WELL NO. Turkey Knob #1

APPLICATION FOR PERMIT TO DRILL, DEEPEN, OR PLUG BACK

Usual Environmental Analysis

Well No. Turkey Knob #1

Modified Rig layout
 per joint onsite
 May 16, 78

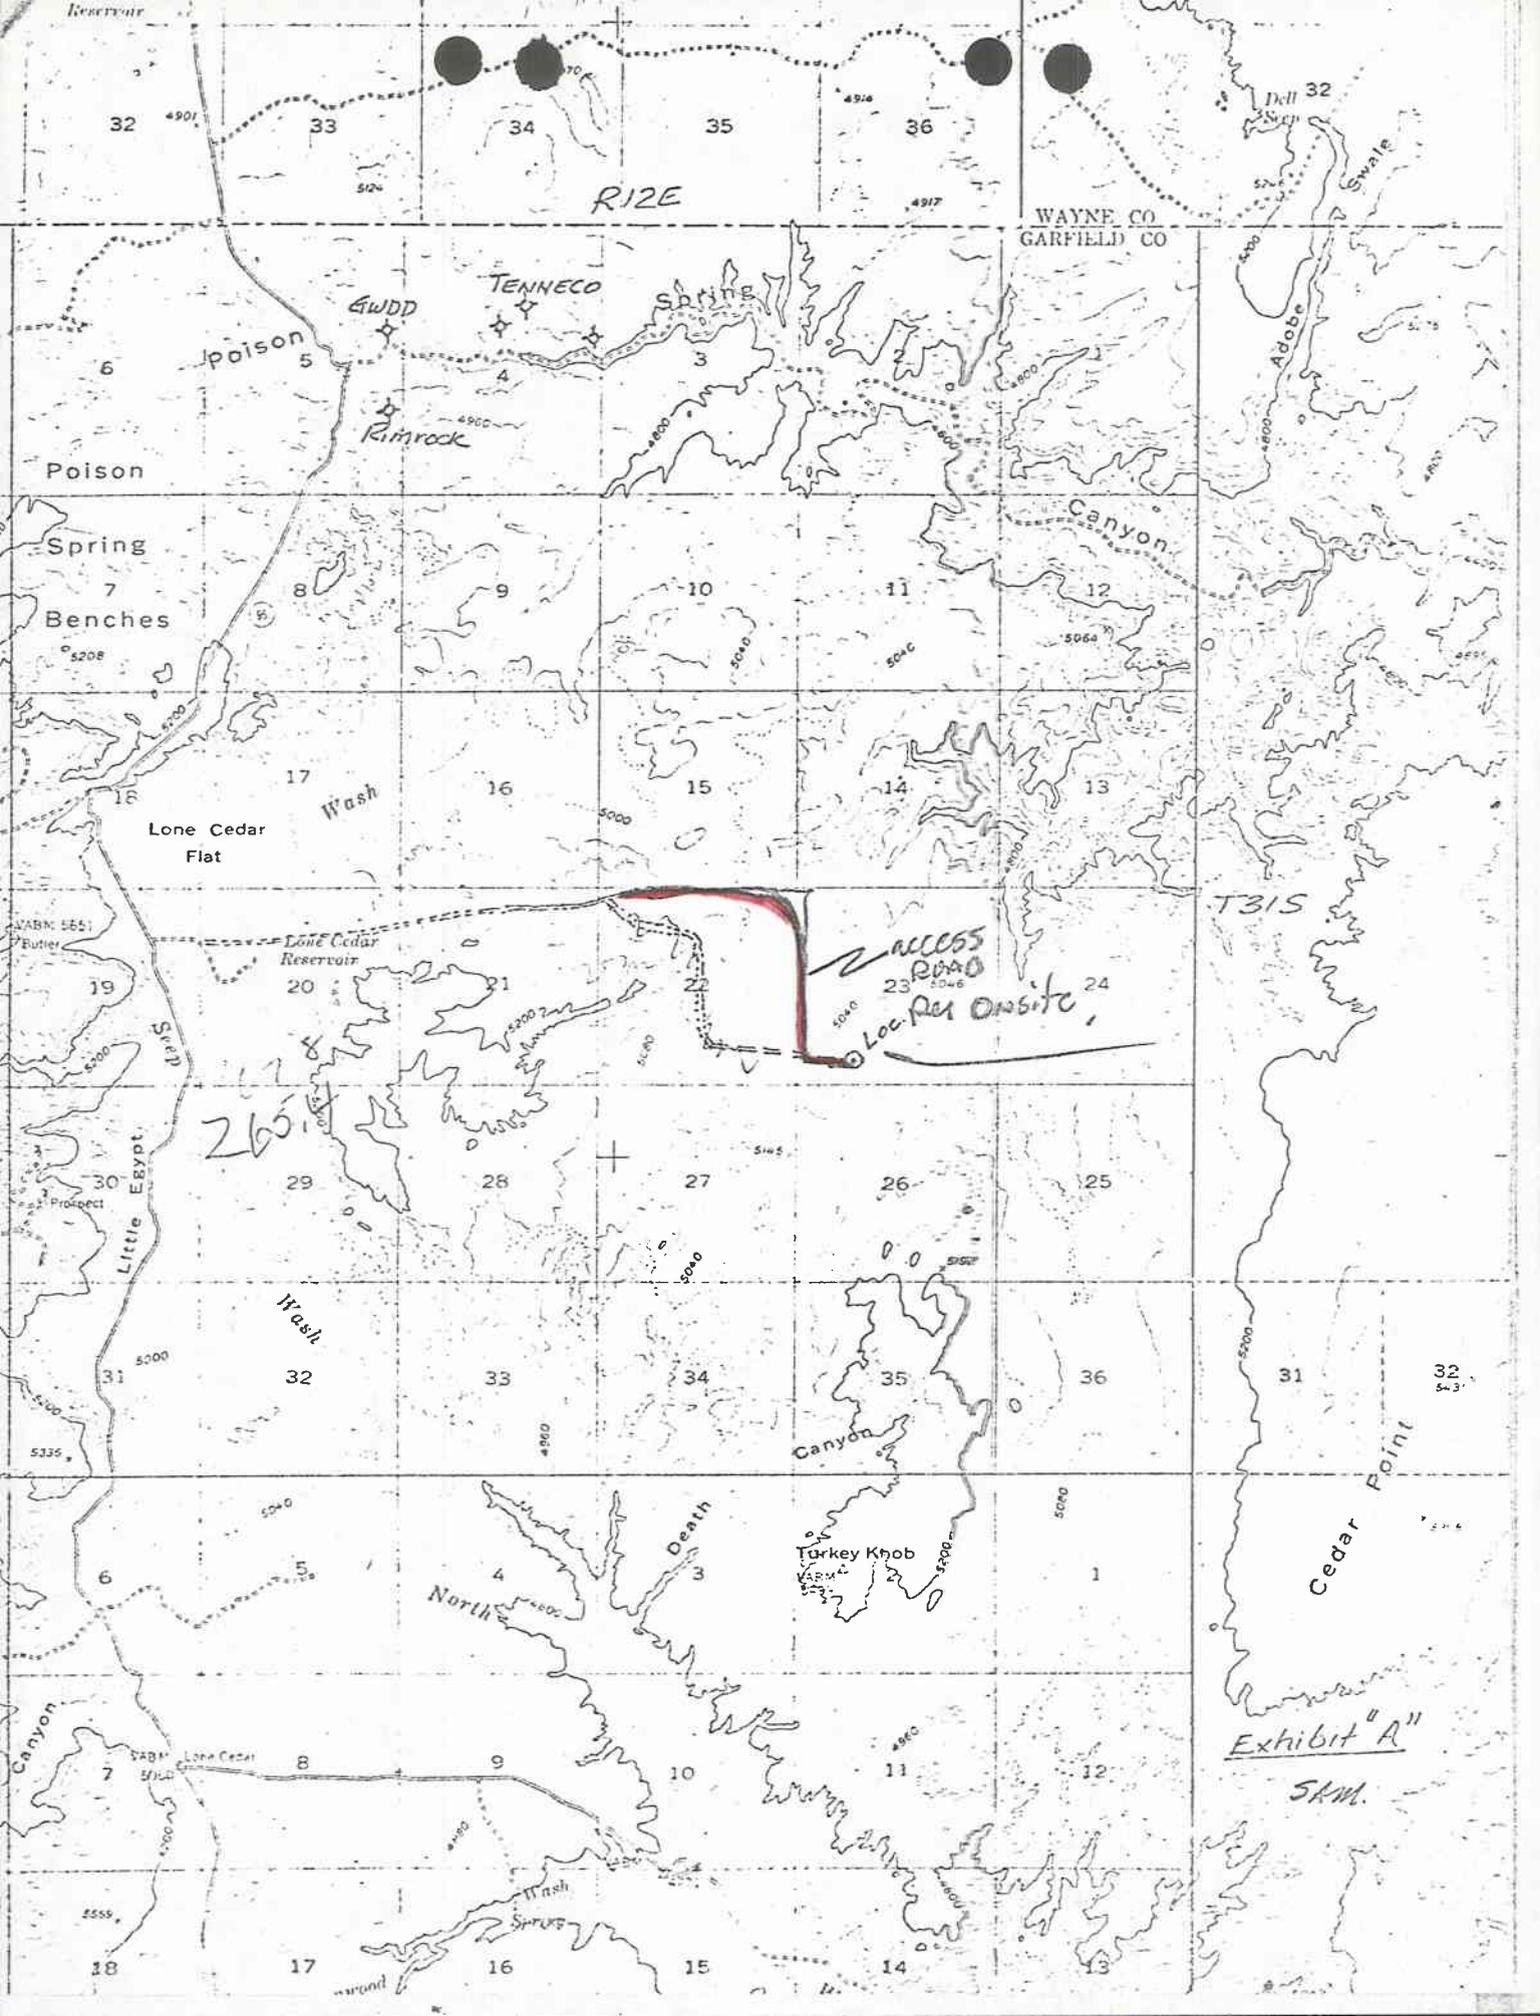
On April 13, 1978, Fulton Oil & Gas, Inc. filed an Application for Permit to Drill the No. Turkey Knob #1 exploratory well, a 6420 foot oil and gas test of the formations above the Precambrian; located at an elevation of 5063 ft. in the SE/4SW/4 Sec. 23, T.31S., R.12E. on Federal mineral lands and Public surface; lease No. U-16861. There was no objection raised to the wellsite. As an objection was made to the access road, it was changed. See the attached map for new access road.

1. The access road was changed to utilize an existing seismic trail which would ^{AVOID} ~~cross~~ ~~lose~~ sand dunes.
